SUBJECT: Calvert Cliffs Nuclear Power Plant
Unit Nos. 1 & 2; Docket Nos. 50-317 & 50-318
Supplemental Data for Request for Relaxation from Certain Inspection
Requirements in NRC Order (EA-03-009) for Reactor Pressure Vessel Head
Penetration Nozzles (TAC Nos. MB7752 and MB7753)

**RESPONSE TO REQUEST FOR ADDITIONAL INFORMATION AND
REACTOR PRESSURE VESSEL HEAD UT EXAMINATION RESULTS**

ADDITIONAL RELAXATION REQUEST

FIGURE 1

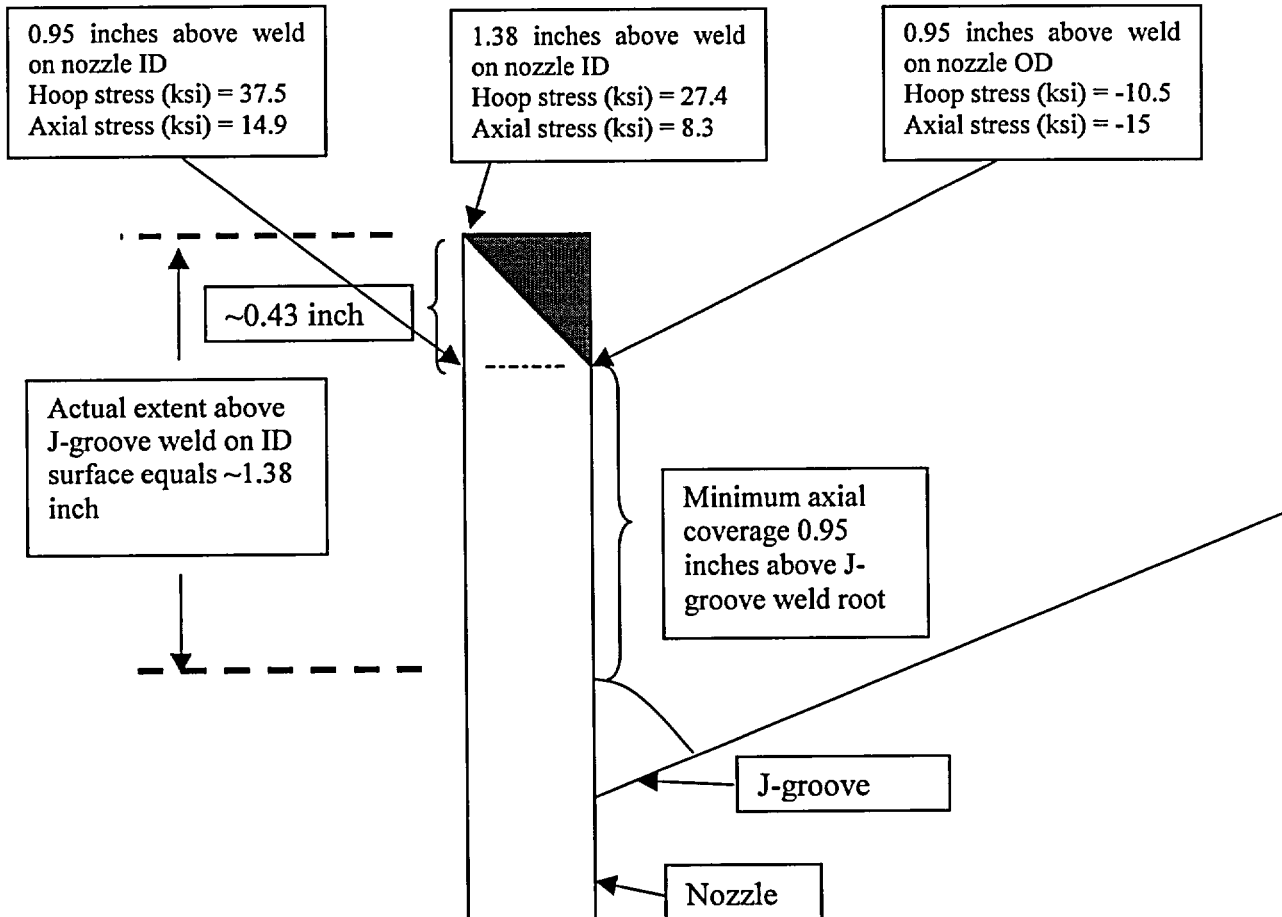
Provide the bounding hoop and axial stresses present at the location of lowest coverage above the J-groove weld.

The requested information is provided on Figure 1 below. The bounding value is located on Nozzle 43 which had coverage to 0.95 inches above the root of the J-groove weld. Nozzle 43 has a 38.5 degree angle with the head. Calculated stresses are reported for a 42.5 degree nozzle, which bounds a 38.5 degree nozzle. Stresses are provided at three locations: on the outside diameter (OD) at the elevation of highest coverage, on the inside diameter (ID) at the same elevation, and on the ID at the elevation of highest coverage. Coverage elevations above the J-groove weld have been reported for coverage on the OD. In all cases coverage on the ID is higher. This is due to the configuration of the transducers in the blade probe and is analogous to the situation at the bottom of the nozzle (see Figure 1 in Attachment 2). Further discussion on the configuration of the transducers in the blade is contained in Attachment (2).

Bounding hoop and axial stresses at elevation of minimum coverage extent above the root of the J-groove weld occurs on Nozzle 43
